NMOCD APPROVED
REMEDATION SUMMARY
AND
SITE CLOSURE
FOR THE
RHOMBUS UNION STATE COM 1
1RP-4671

NMOCD APPROVED SOIL REMEDIATION WORK PLAN FOR INCIDENT 1RP-4671

FRONTIER FIELD SERVICES LLC
RHOMBUS UNION STATE COM # 1
SECTION 32, TOWNSHIP 18S, RANGE 34E
LEA COUNTY, NEW MEXICO

Subject: Frontier Field Services, LLC
Remediation and Closure of Rhombus Union State Com 1
1RP-4671

Final Chloride Sample # 10

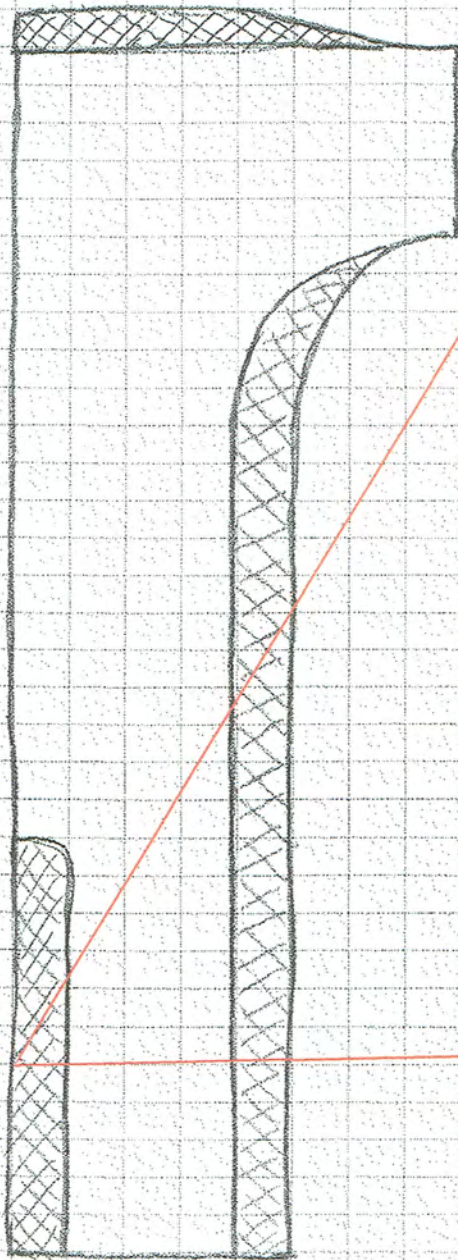
Sample #10 Location

Frontier excavated additional soil from the Sample #10 location on June 27th and 28th and then resampled on June 29th, with samples collected from the surficial soil (Sample 10-A) as well as two (2) feet bgs (Sample 10-B) and four (4) feet bgs (Sample 10-C). All samples were reported below the chloride cleanup level of 600 mg/kg, however, as five (5) feet of soil below the chloride cleanup level has not been demonstrated, Frontier proposes collecting an additional sample from this location at five (5) feet bgs.

Final Chloride Sample # 5

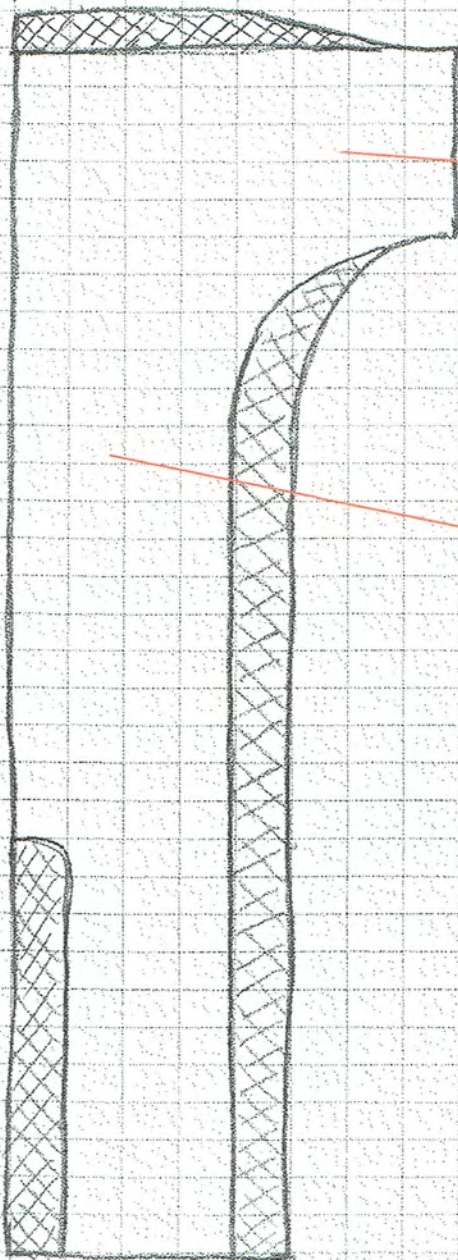
Sample #5 Location

Frontier excavated additional soil from the Sample #5 location on June 27th and 28th and then resampled. The sample collected from five (5) feet bgs on June 29th (Sample Repeat #5) was reported below the applicable chloride cleanup level. Frontier proposes collecting an additional sample from this location at ten (10) feet bgs to demonstrate that there is five (5) feet of soil that meets the permissible chloride level.

Final Chloride Sample # 6

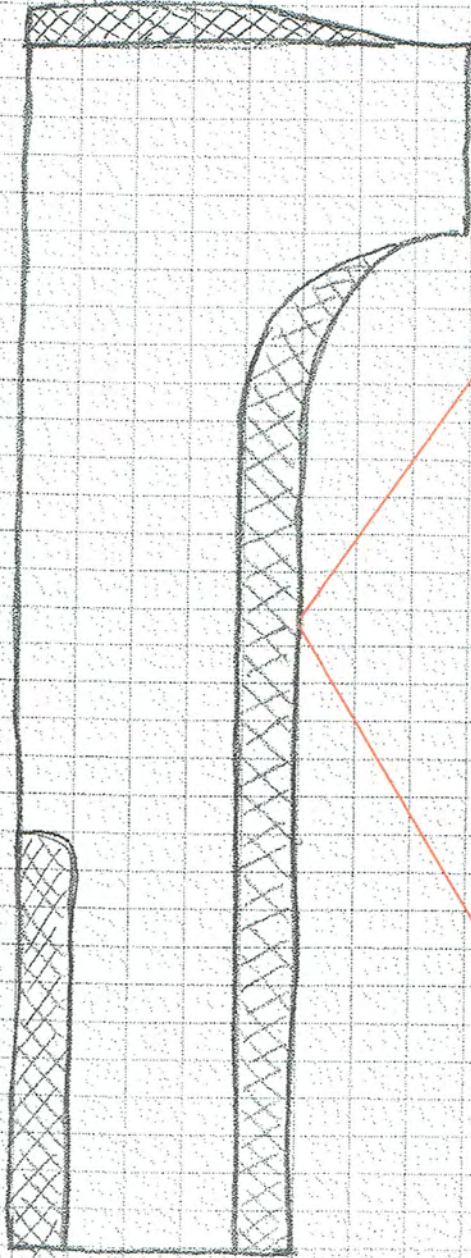
Sample #6 Location

Frontier excavated additional soil from the Sample #6 location between June 27th and 29th and then resampled on June 30th, with samples collected from the surficial soil (Sample 6-A) as well as 2.5 feet bgs (Sample 6-B) and five (5) feet bgs (Sample 6-C). All samples were reported below the chloride cleanup level of 600 mg/kg, and no additional excavation or sampling is proposed at this location as five (5) feet of soil which meet the chloride cleanup level has been demonstrated (Sample 6-A, 6-B and 6-C collected on June 30th).

Final Chloride Sample # 1

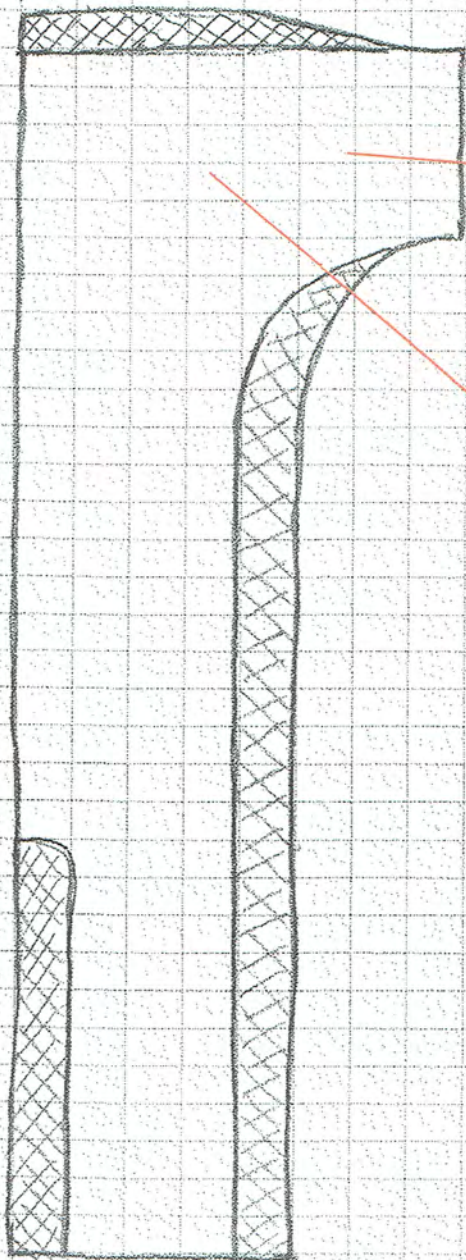
Sample #1 Location

Frontier excavated additional soil to a depth of seven (7) feet bgs from the Sample #1 location on June 27th - 29th, and then resampled. The final sample collected on July 6th was reported below the applicable chloride cleanup level. Frontier proposes collecting an additional sample from this

location at 12 feet bgs to demonstrate that there is five (5) feet of soil that meets the permissible chloride level.
